**Planning, Zoning & Economic Development
Memorandum**

DATE: October 5, 2021

A. Project Name / Number: 8601 W. Sunrise Redevelopment / PP20-0016

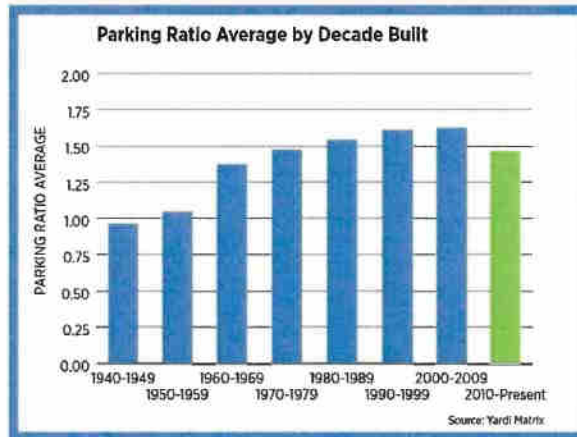
- a. Building 1 – 95.91-foot setback to the east and 76.41-foot setback to the west;
- b. Building 2 – 112-foot setback to the west;
- c. Building 3 – 57-foot setback to the west and 39-foot setback to the south (scaled at the southeast corner of the building);
- d. Retail building – 33.33-foot setback to the east;
- e. Office building – 29.25-foot setback to the east; and
- f. Parking garage – 28.91-foot setback to the east and 21-foot setback to the north

Applicant justification: The Code required setbacks would have a substantial impact on the amount of buildable space and park area the Applicant would be able to provide. With this waiver, a larger green area and a larger amenity area can be provided. Additionally, parking ratios, pedestrian walking paths, amenity areas, and circulation would also be negatively impacted if the Applicant was required to meet the Code.
